Project THE CEDAR 2 FRINGEWOOD CLOSE NORTHWOOD HA6 2TB			
Drawing PROPOSED PLANS: GROUND, FIRST & ROOF			
SEABROOK ARCHITECTS CHARTERED ARCHITECTS 17 Chiltern Court, Asheridge Road, Chesham, Bucks HP5 2PX Tel: 01494 778918 e-mail: info@gsparchitects.co.uk			
Drawn By NHQ		Date	June 2021
Checked By Checked by		Date	Checked date
Approved By Approved		Scale	1:100@A2

Drawing No. 5835/PL103		Rev.	C

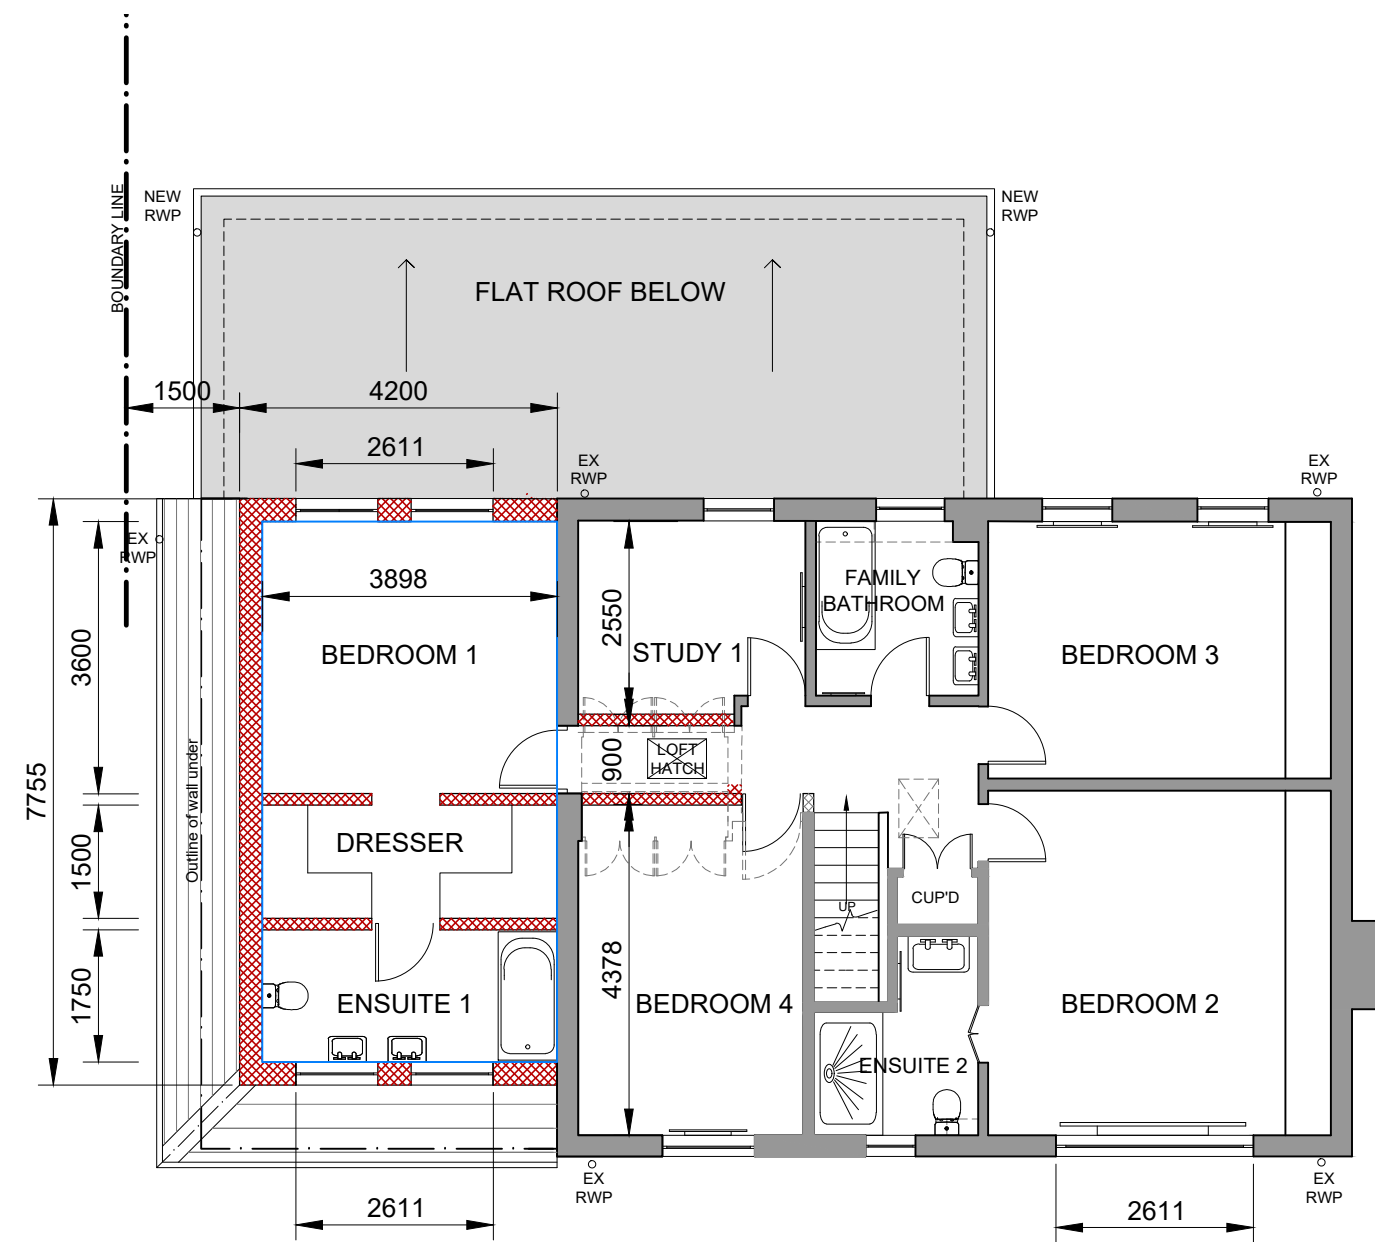
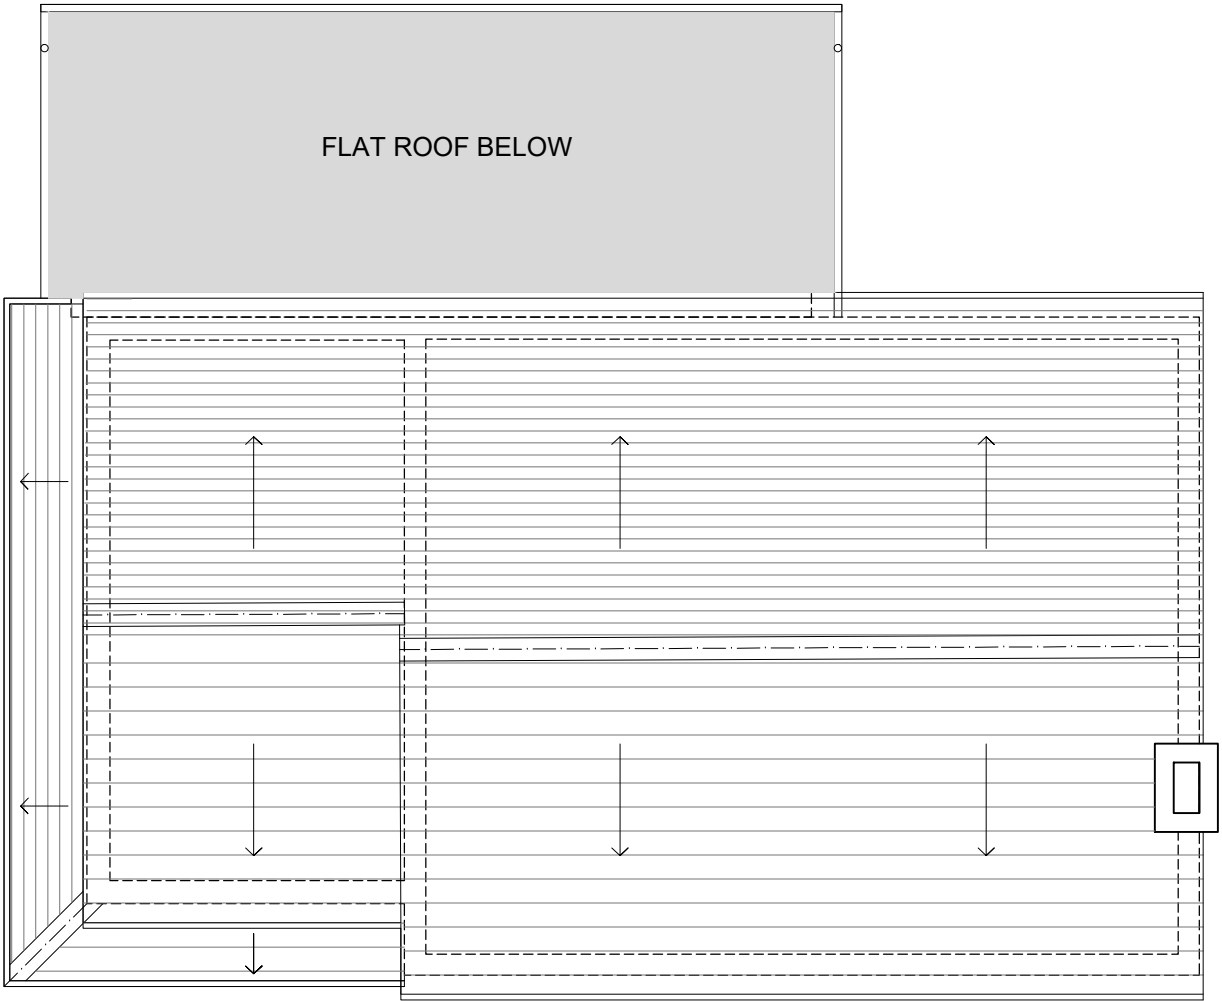
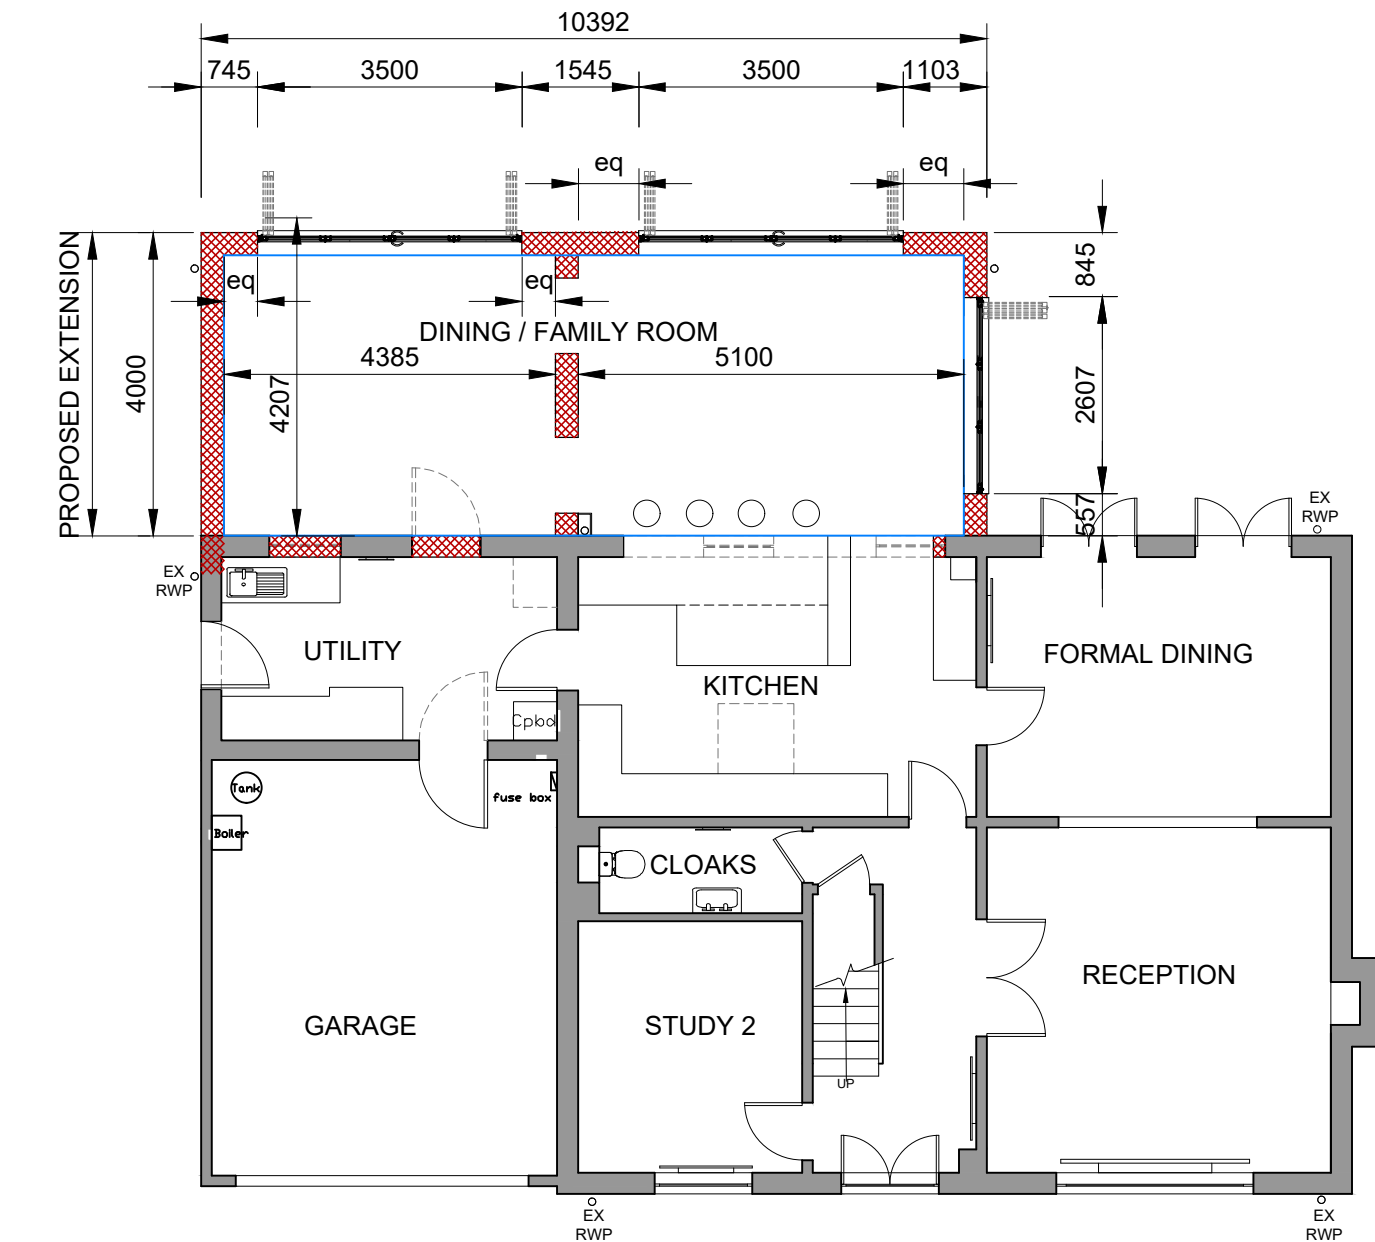
Amendments/Notes			
Rev.	Detail	By	Date
A	Window to extension & roof line over garage amended	NHQ	05.07.2021
B	Window above garage amended	NHQ	06.07.2021
C	Rear extension reduced to 4.0m - Planning requirement	MD	21.09.2021
LEGEND EXISTING DEMOLISHED EXISTING WALLS RETAINED NEW WALLS TO MATCH EXISTING			
PLANNING All dimensions and levels to be checked on site by contractor prior to preparation of shop drawings and commencement of work on site. This drawing and the copyrights and patents therein are the property of the Architect and may not be used or reproduced without consent. This drawing is to be read in conjunction with all relevant consultants and/or specialist's drawings/documents and any discrepancies or variations are to be notified to the Architect before the affected work commences. All works on site are to be carried out fully in accordance with current CDM regulations and recommendations, current Building Regulations, British Standards and Codes of Practice as appropriate.
